UNITED STATES PATENT AND TRADEMARK OFFICE

10/571,056

Francois Le Maner

Office Action Summary	Application No. 10/571,056	Applicant(s) LE MANER, FRANCOIS	
	Examiner MICHAEL HAGEDORN	Art Unit 4159

Figure 1 – Lina et al (US Patent 5,190,192)

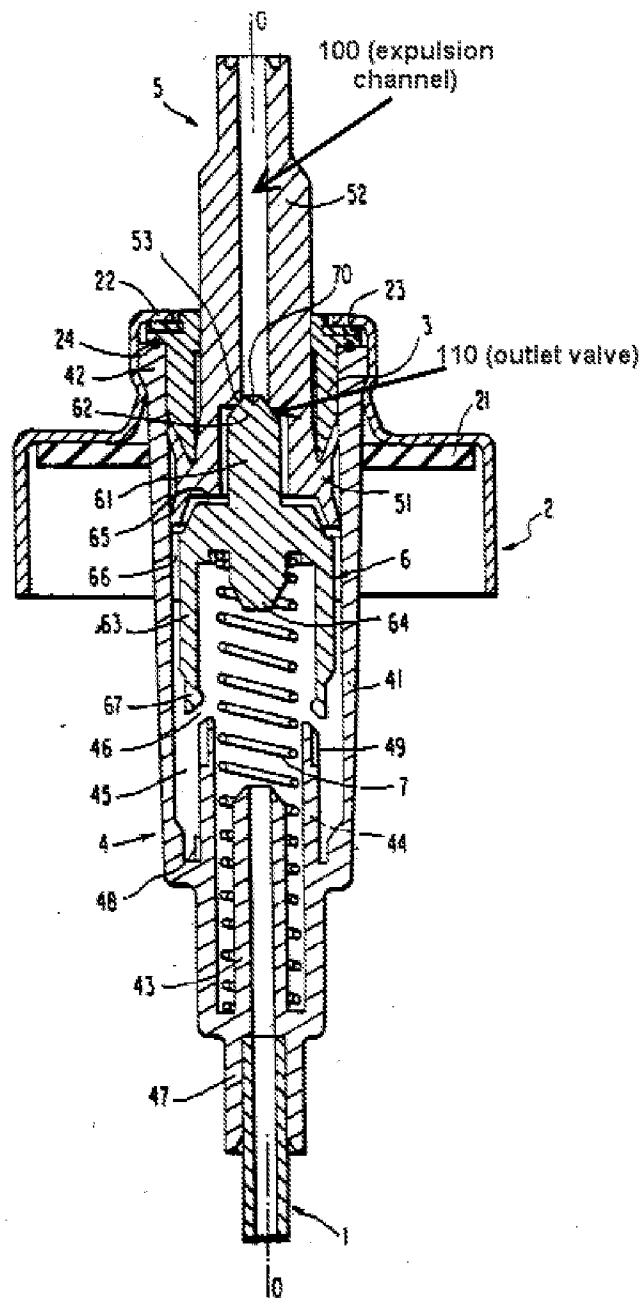
4. In Re claim 1, with reference to figure 1 below, Lina et al discloses A fluid dispenser pump comprising a pump body (4) a pump chamber (45) provided with an inlet valve (46) and with an outlet valve (110), and a piston (5) sliding in said pump body (4) so as to dispense the fluid contained in the pump chamber (45), said outlet valve (110) comprising a valve element (61) co-operating with a valve seat (53) the fluid dispenser pump being characterized in that said outlet valve (110). However, Lina et al fails to disclose an outlet valve comprising a deformable sealing means provided

5. In re claim 2, with reference to figure 1 above, Lina et al discloses a pump, in which said piston (5) is secured to an actuator rod (52), said actuator rod being hollow and defining an expulsion channel (100) for the fluid, said valve seat (53) being formed in said expulsion channel (100).

6. In re claim 3, with reference to figure 1 above, Lina et al discloses a pump in which, while the pump is being actuated, the outlet valve (4) is urged towards its closed position by a spring (7), said valve (110) being opened by the pressure of the fluid contained in the pump chamber (45).

10. In re claim 7, Lima discloses a frustoconical surface (62). This surface would cooperate with the deformable annular lip of claim 6, when in the closed position (fig. 1 of Lima).

Figure 3a – Crosnier et al (US Patent 6,932,246)

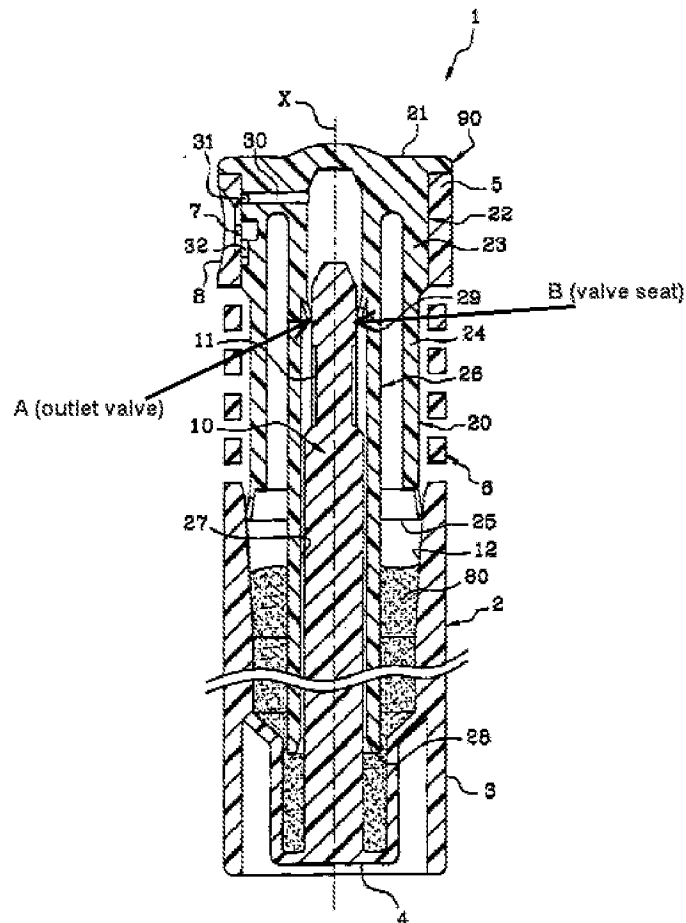
Crosnier et al, with reference to figure 3a below, does disclose an outlet valve (A) further comprising a deformable sealing means (29) provided between said valve seat (B) and said valve element (10), said sealing means (29) being elastically deformed (Column 3, lines 63-66) when said outlet valve (A) is in the closed position, so as to improve sealing. It would have been obvious to one of ordinary skill in the art to implement Crosnier's teaching into Lina's because as stated in the claim would these teachings will improve the sealing between the outlet valve and valve element.

7. In re claim 4, Crosnier et al, with reference to figure 3a above discloses a pump in which said deformable sealing means (Column 3, lines 63-66) is formed on the valve seat (B). However, it would have been obvious to one having ordinary skill in the art at the time the invention was made to have a pump in which said deformable sealing means is formed on the valve element, since it has been held that a mere reversal of essential working parts of a device involves only routine skill in the art. In re Einstein, 8 USPQ 167. Please note that in the instant application, applicant has not disclosed any criticality for the claimed limitations.

8. In re claim 5, Crosnier et al, with reference to figure 3a above, discloses a pump in which said deformable sealing means (Column 3, lines 63-66) is formed on the valve seat (B).

9. In re claim 6, the sealing means of Crosnier et al, with reference to figure 3a above comprises at least one deformable annular lip (29).

11. In re claim 8, Crosnier et al, with reference to figure 3a, above, discloses that said annular lip (29) is made by molding (column 7, lines 34-37). In accordance to MPEP 2113, the method of forming the device is not germane to the issue of patentability of the device itself. Therefore, this limitation has not been given patentable weight. Please note that even though product-by-process claims are limited by the defined by the process, determination of patentability is based on the product itself. The

12. In re claim 9, Crosnier et al, with reference to figure 3a above, discloses a pump, in which the valve seat (B) includes a flexible annular lip (29) co-operating with a frustoconical valve element (10), said valve element (10) being substantially rigid.

13. In re claim 10, Crosnier et al, with reference to figure 3a below, discloses a pump, in which the valve seat (B) is made out of two materials, said annular lip (29) being made out of a material that is softer than the remainder of the valve seat (B).

Figure 4 – Roger (US Patent 4,420,011)

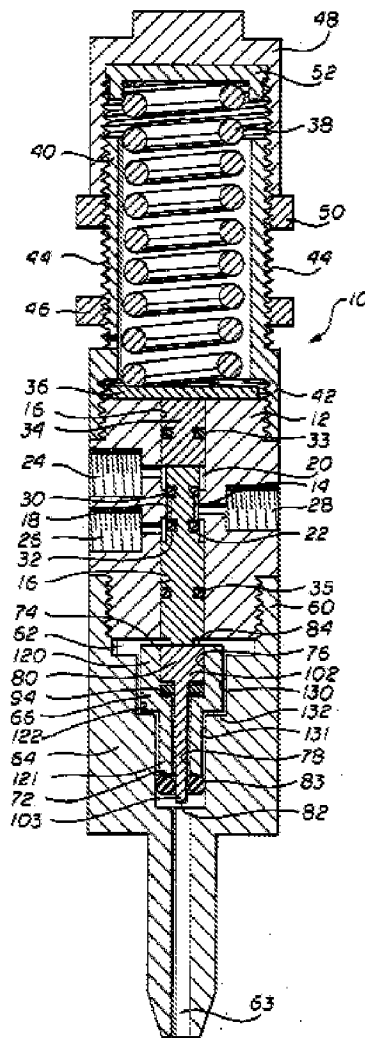
16. In re claim 11, Lina has been discussed above, but doesn't disclose a pump in which said deformable sealing means comprises a deformable O-ring. However Roger, with reference to figure 4 below, discloses a pump in which said deformable sealing means comprises a deformable O-ring (83). The claim would have been obvious because the substitution of one known element for another would have yielded predictable results to one of ordinary skill in the art at the time of the invention.

17. In re claim 12, Roger with reference to figure 4 above said O-ring (83) co-operates with a frustoconical surface when the valve (103) is in the closed position. This surface would cooperate with the O-ring of claim 11, when in the closed position (Fig 1 of Lima).

18. In re claim 13, Roger, with reference to figure 4 above discloses said O-ring (83), secured by interfitting, snap-fastening, or overmolding. In accordance to MPEP 2113,

19. In re claim 14, Roger with reference to figure 4 above discloses the valve element (103) is substantially rigid and includes a deformable O-ring (83) co-operating with a fustoconical valve seat (82), said valve seat (82) being substantially rigid.
